VICTORVILLE 2 HYBRID POWER PROJECT (07-AFC-01)
CEC STAFF DATA REQUEST NUMBERS 62-84

Technical Area: Soil and Water Resources

Response Date: July 23, 2007

Figure DR71-1

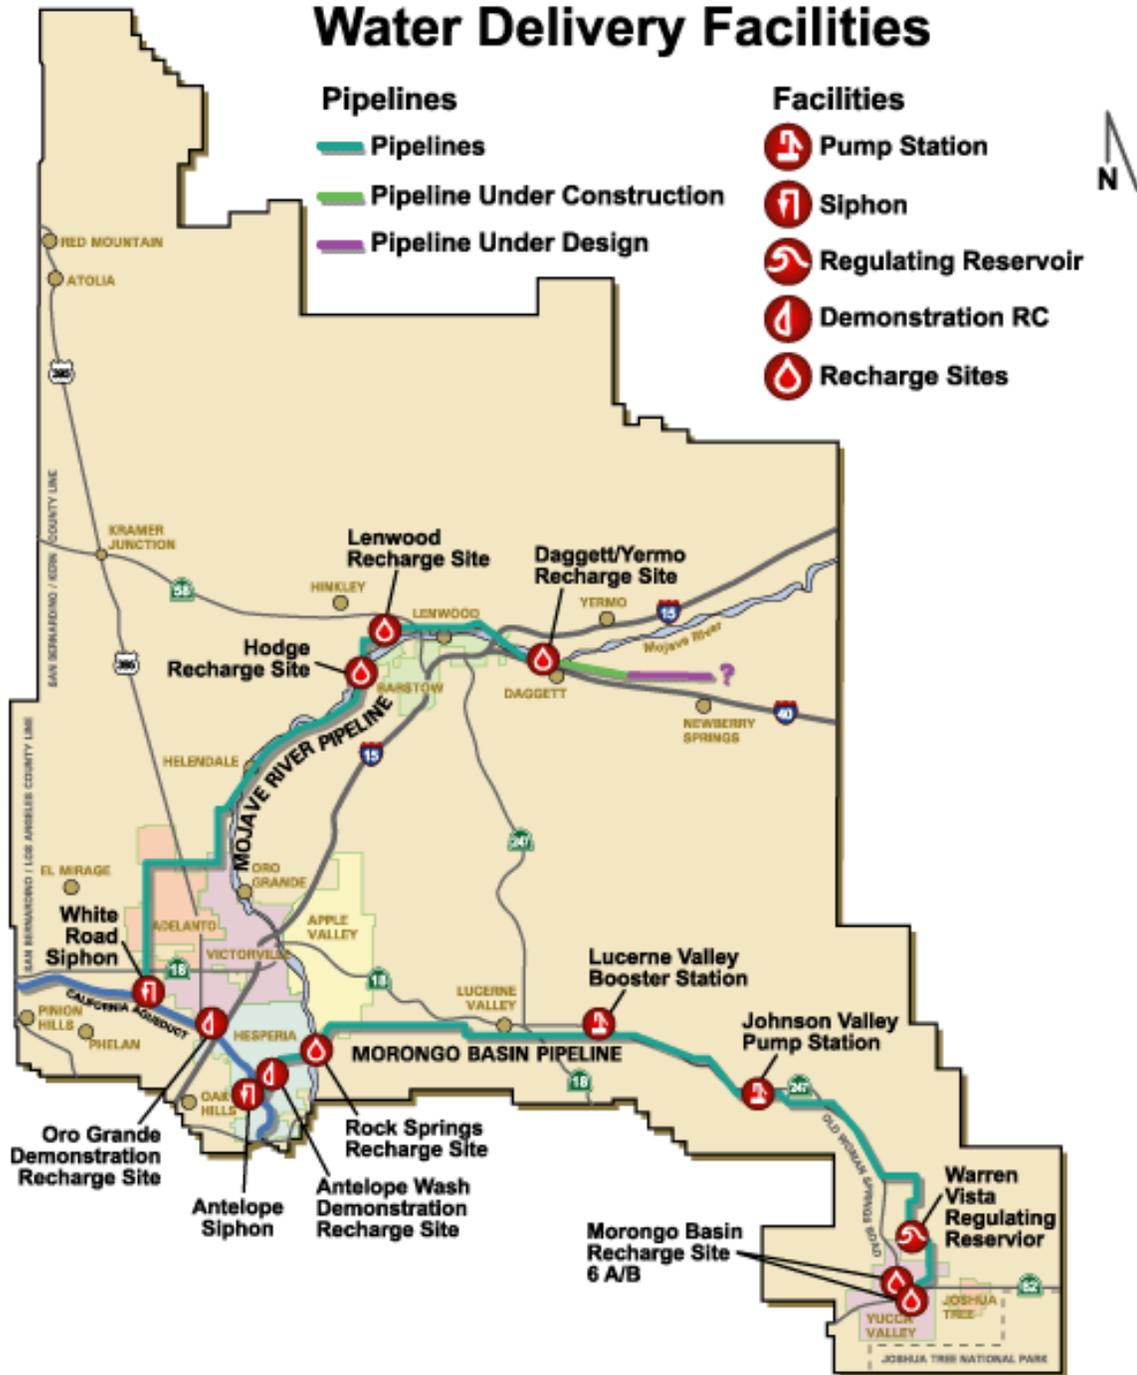
- a. Changes in recharge that have occurred in each of the sub areas of the Mojave Basin during the last 10 years; include information on water importation, reclamation of wastewater and new recharge programs.
- b. MWA's recharge projects using SWP and reclaimed water including:
 - i. a map of the site location and a description of current recharge rate, recharge capacity, hydrology and hydrogeology for each site; and
 - ii. any available assessments of the recharge performance of these projects.
- c. Please provide a regional water budget and discuss the status of overdraft of the Mojave Basin.

- b.i. Figure DR71-1 is a map of the MWA recharge sites and Table DR71-1 provides data about the recharge sites. Recharge rates throughout the basin are estimated to be about seven ft/day (see Attachment DR71-2, Mojave River Basins Groundwater Recharge Study). A specific assessment at Oro Grande Wash determined recharge rates to average 2.8 ft/day (see Attachment DR71-3).
